# UNITED STATES PATENT AND TRADEMARK OFFICE

<b>Office Action Summary</b>	<b>Application No.</b> 10/581,341	<b>Applicant(s)</b> KLEIN, JEAN-PIERRE	
	<b>Examiner</b> DANIEL KENNY	<b>Art Unit</b> 3633

## DETAILED ACTION

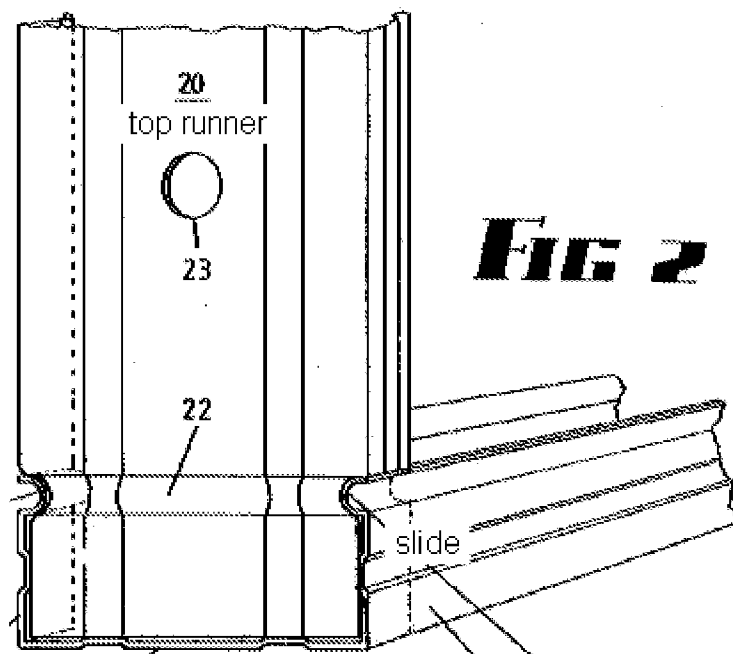
Regarding the floor plates 11 anticipating the slide, the following annotated figure may help further describe the rejection:

Applicant argues that “there is no suggestion in KARYTINOS of floor plate 11 as teaching a slide” because the claim recites:

the slide movable relative to a top runner in a vertical direction;  
the top runner fixed; and,  
the snap-fitting means is reversible.

The slide is movable relative to a top runner in a vertical direction, as the “top runner” essentially snaps in and out of the “slide”. The top runner is claimed as being capable of being fixed to the ceiling, and the “top runner” of Karytinios is so capable, as it can be secured at the top end to a ceiling. The snap-fitting is reversible, at least to the extent that essentially any connection is reversible to some degree.
